PLANNING COMMISSION STAFF REPORT

Originator Cary Teague Director of Planning	Meeting Date April 9, 2014	Agenda # VI.C
--	--------------------------------------	-------------------------

Mathias Mortenson is proposing to tear down a single-family home and construct a new double dwelling unit at 3923 49th Street. (See property location on pages A1–A5, and the applicant’s plans and narrative on pages A6–A32.) The property is located adjacent to the 50th and France retail area; just north of the former Edina Realty Building site, now owned by the City of Edina, and east of a four story apartment building. To accommodate the request the applicant is requesting the following:

PRELIMINARY PROPOSED GRADING PLAN

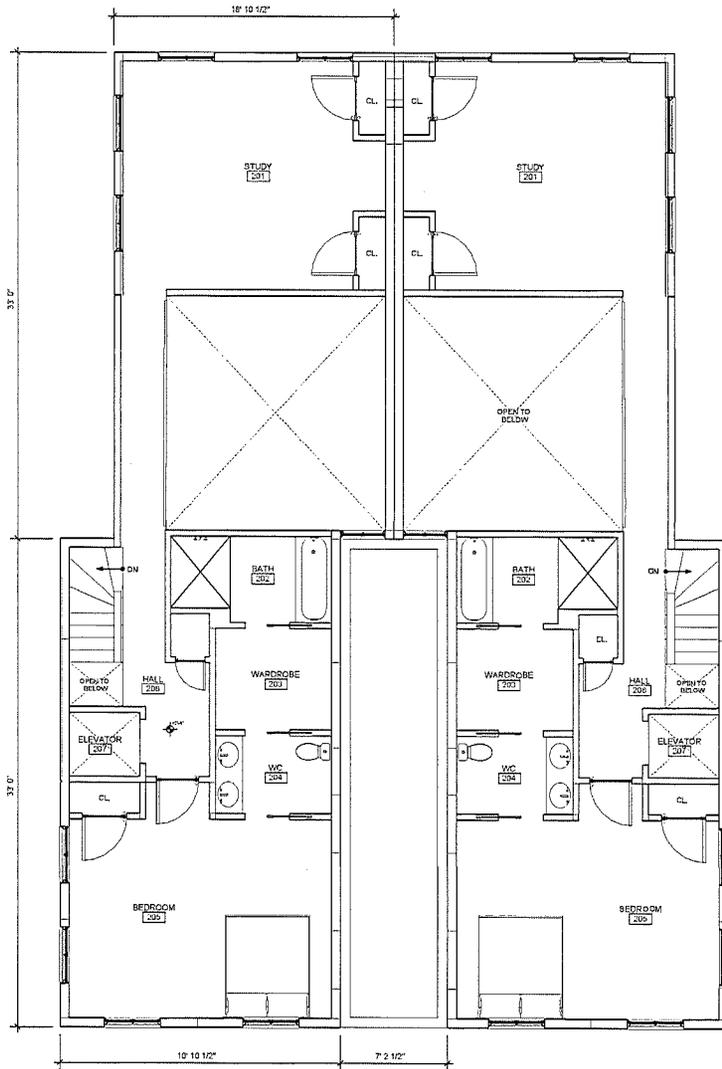
Concern was also raised in regard to the retaining walls and safety. With the elimination of one of the driveways, part of the retaining wall issue is addressed; however, there still is a retaining wall that would exceed four feet in height that would be right on the existing lot line. The previously stated safety concerns would remain for the adjacent property to the west, as there would be a five-foot drop from that side lot line at the end of the driveway. (See page A14.)

1. Egress well and driveway drain to landlocked areas adjacent to the foundations. It appears that there is no plan for drainage aside from calling out a 'French drain.' These areas should include either positive grade away from the foundation or a drainage system should be included that drains away.
2. It appears there is are drainage and erosion control plans proposed. A registered Civil Engineer should design these two plans.
3. There is a 8' drop near the concrete walk adjacent to the driveway, and adjacent to the patio near the egress well. I believe building code requires a railing for anything over 30-inches.
4. There are 6+ retaining walls directly adjacent to the neighboring property to the west. Any wall over 4' will require structural engineering. This wall will require permission from the neighboring property to be constructed?
